ADDENDUM NO. 1

MIDWESTERN STATE UNIVERSITY
MOFFETT LIBRARY RENOVATION
PHASE I

Addendum Date: 2 April 2018

P-103

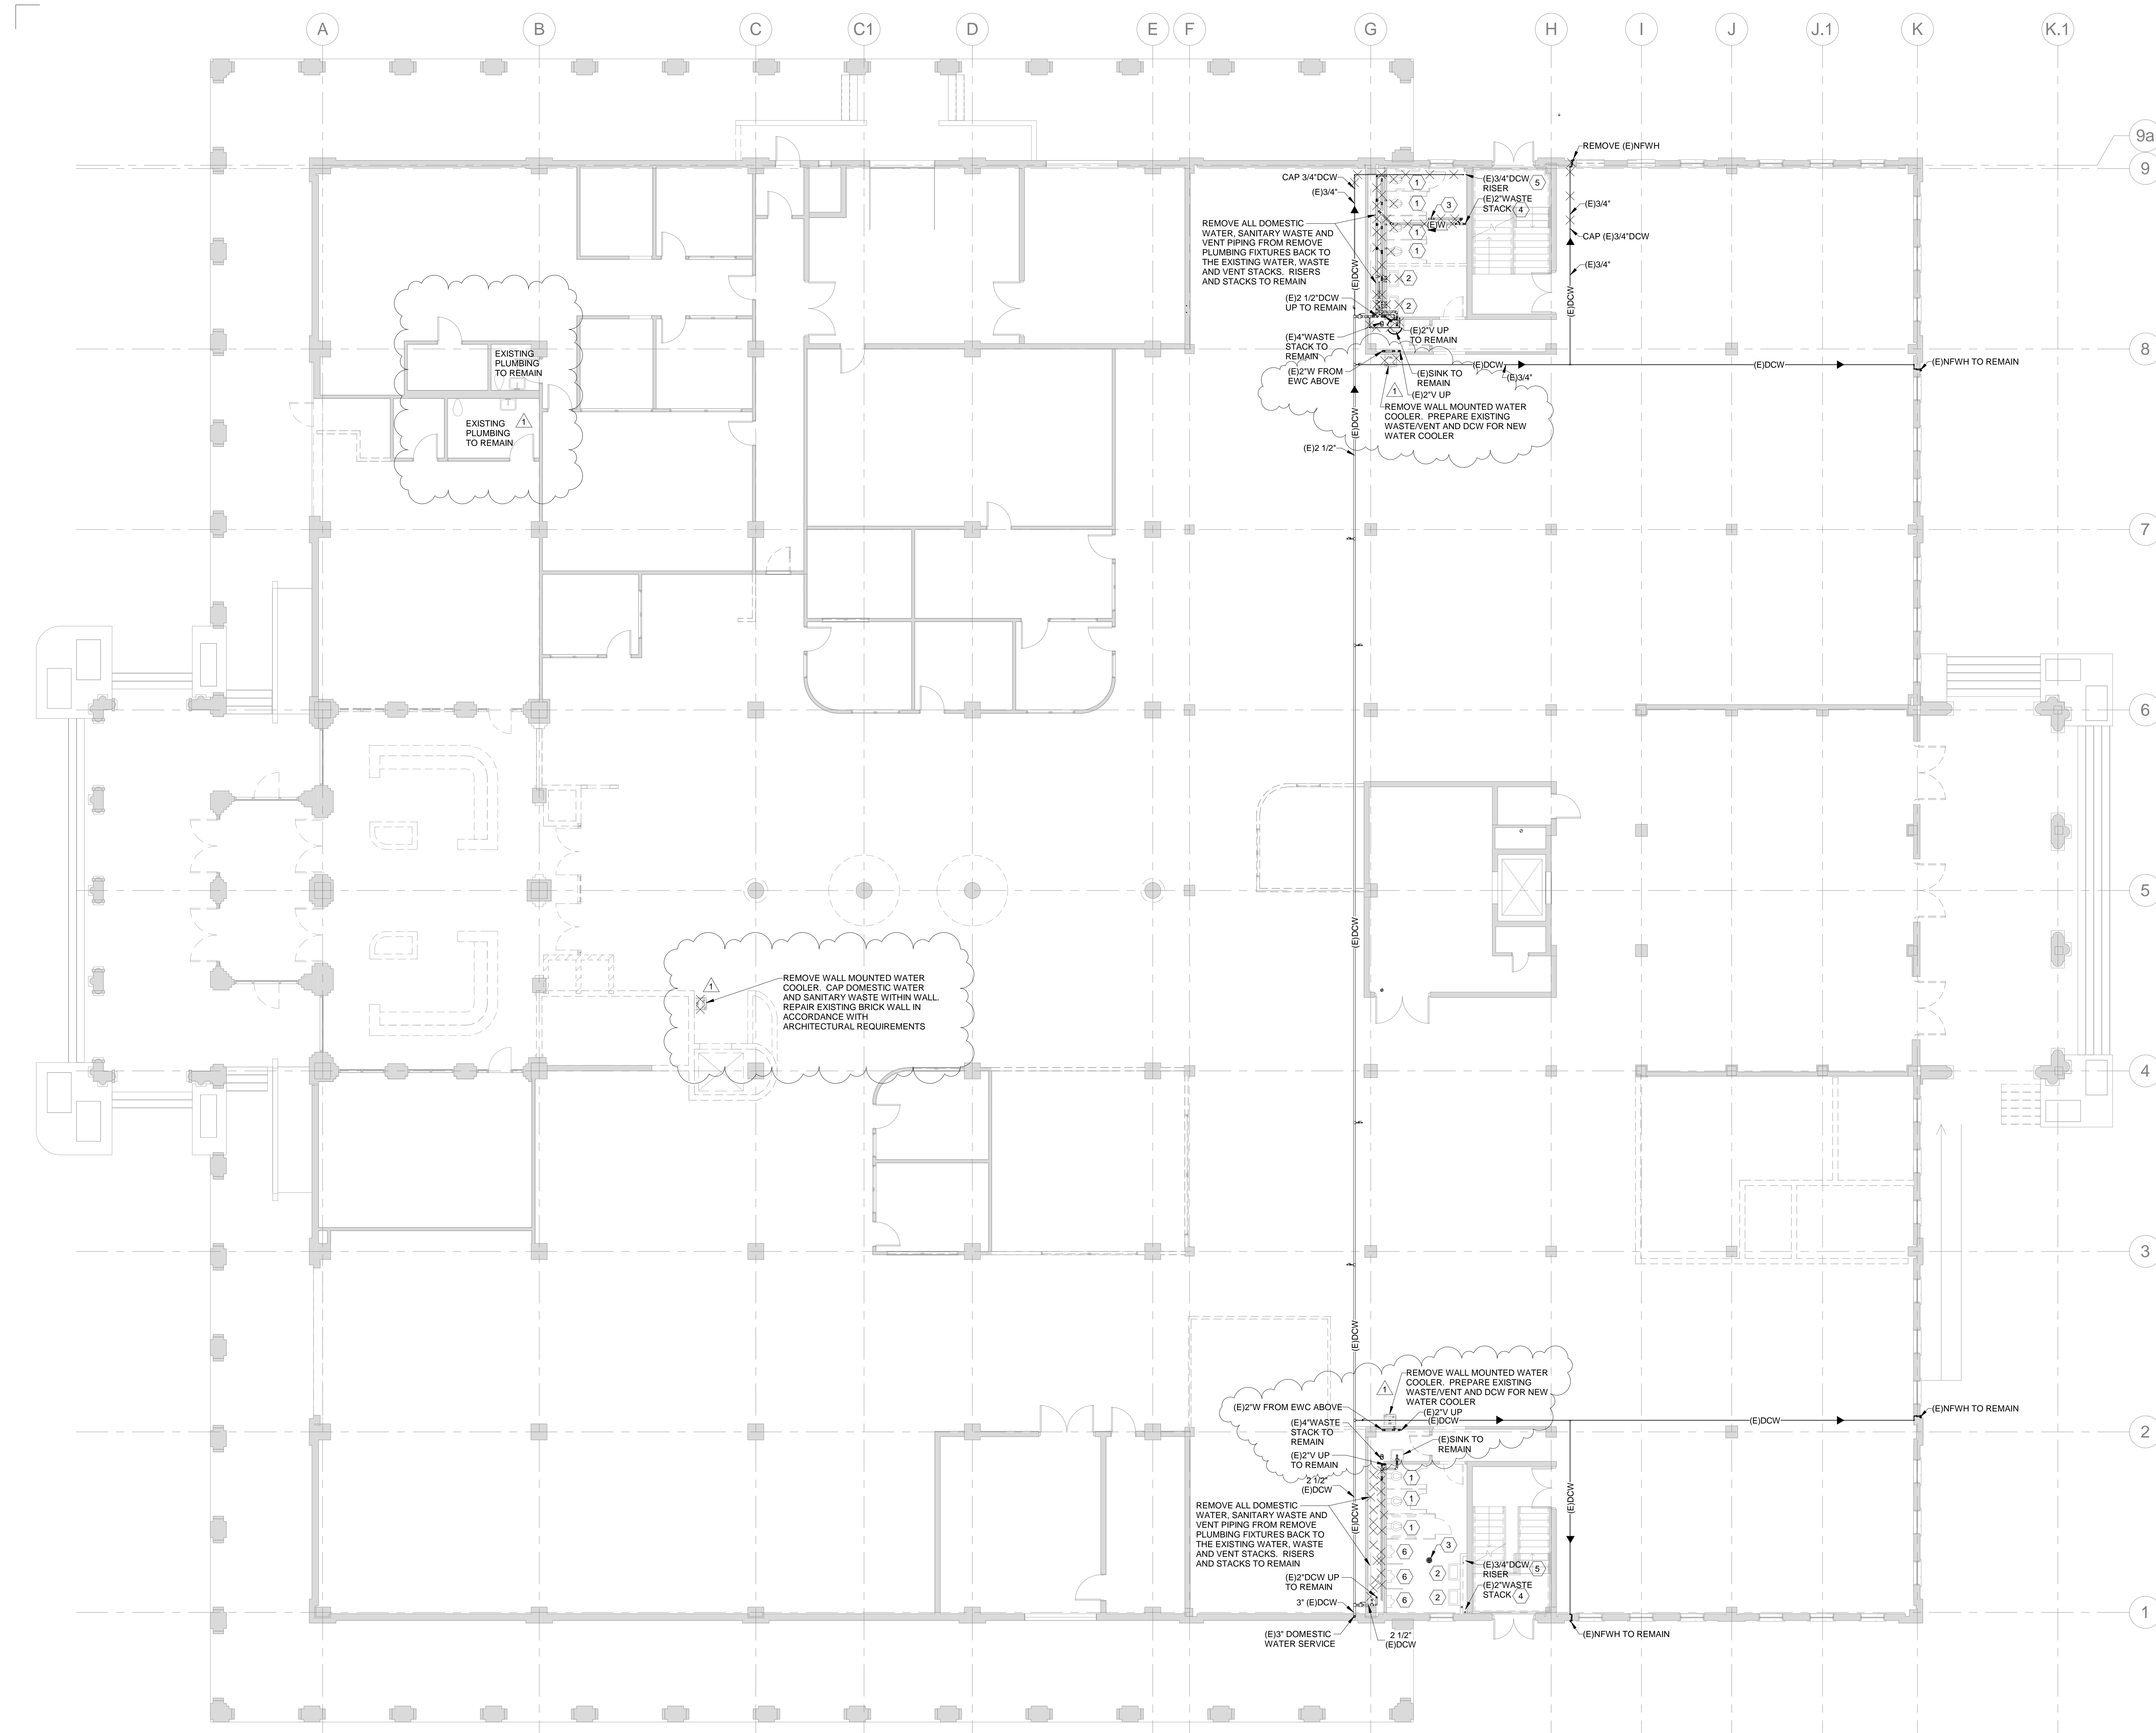
Replace the Drawings the revised Sheets attached in this Addendum. Additions and revisions have been made to the Plumbing Plans and Plumbing Demolition Plans on all Floors, mainly relating to Electric Water Cooler Units and IT Closets. Also, revisions have been made to the "PLUMBING FIXTURE SCHEDULE" and the "ELECTRICAL DEMO FIRST FLOOR".
